Work Order ID 138705

Item Name: Heli-Access Step, Short, High Gear

DART SERVICE INSTRUCTION

TO AMEND INSTALLATION INSTRUCTIONS D350-591 REV. G
AND INSTRUCTIONS FOR CONTINUED AIRWORTHINESS ICA-D350-591 REV. 3

FIGURE 32-9: Crosstube Attachment
REF ICA-D350-591

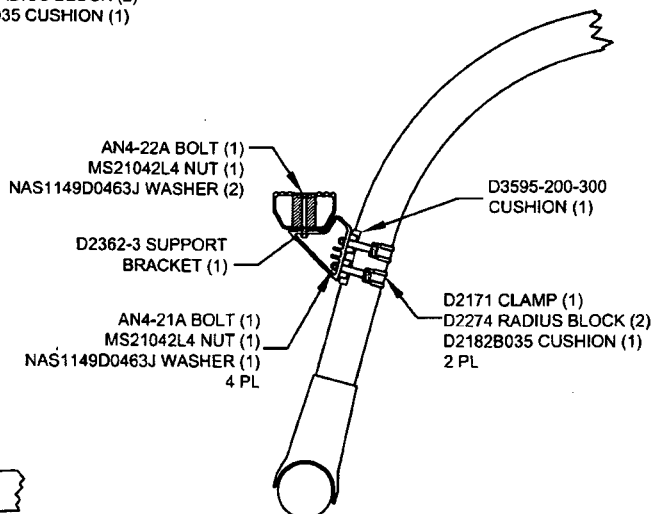
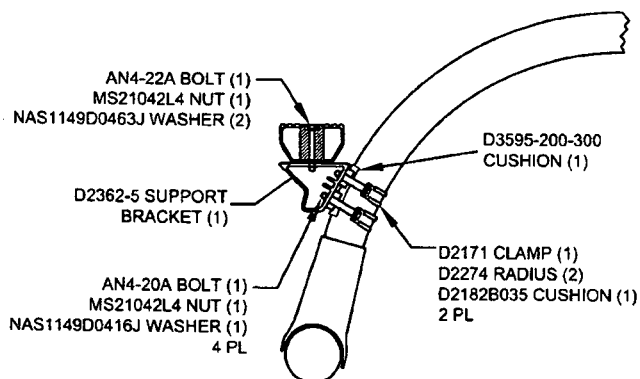
TO PROVIDE AN OPTIONAL CUSHION KIT TO BE INSTALLED ON THE D350-591-111A/-113/-115/-117A/-119 *Heli-Access-Step*™ (THE D2856-400-720 ABRASION STRIP IS REPLACED WITH THE D3595-200-300 CUSHION).

1. REMOVE THE STEP PER ICA-D350-591 SECTION 32.2
2. REMOVE THE D2856-400-720 ABRASION STRIP PER ICA-D350-591 SECTION 32.4
3. POSITION THE D3595-200-300 CUSHION AS INDICATED ON SHEET 3 OR 4 (AS APPLICABLE) OF THIS SERVICE INSTRUCTION.
4. REINSTALL THE STEP PER ICA-D350-591 SECTION 32.1 AS APPLICABLE USING THE NEW HARDWARE PROVIDED AS SHOWN ON SHEET 3 OR 4 (AS APPLICABLE) OF THIS SERVICE INSTRUCTION.
